1 - BASEMENT LIGHT WELL DETAIL:

Architect / Originator:  Tate Harmer  Unit G1B2, Stamford Works, 3 Gillett Street, London N16 8JH Tel: +44 (0)207 241 7481 Email: studio@tateharmer.com	Do not scale. All did to be checked on s This drawing is cop	ite.
	Client: Platinum Land 8 Queripel House, 1 Duke of York Sqaure, Kings Road, London, SW3 4LY		
	Project: Belsize Park Firestation	Date of Origin: 15.03.18	Drawn By: RB
	Drawing Title: BASEMENT LIGHT WELL BALUSTRADE DETAILS	Scale/s: 1: 5	
lient Sign Off	Drawing Number: BFS THA PR AL 640 P3 Revision	Drawing Status: Planning

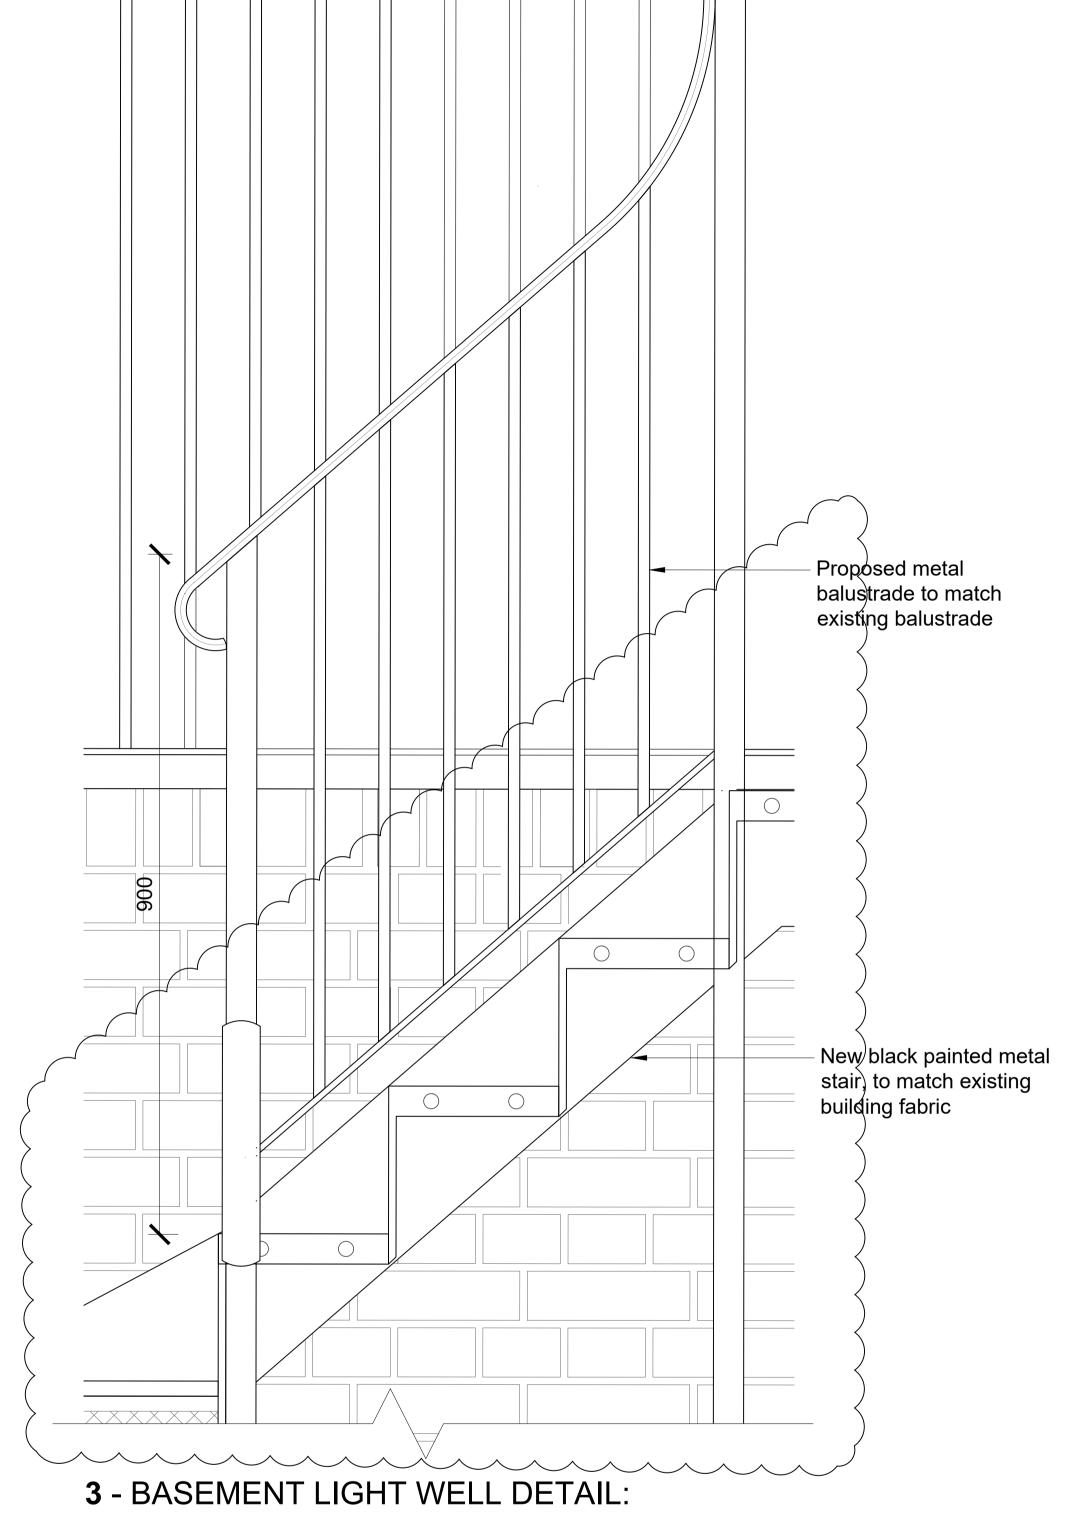
List of changes from consented scheme:

- Amendment of lightwell stair to metal with a black painted finish.
- Stone coping detail to lightwell wall replaced with facing brick
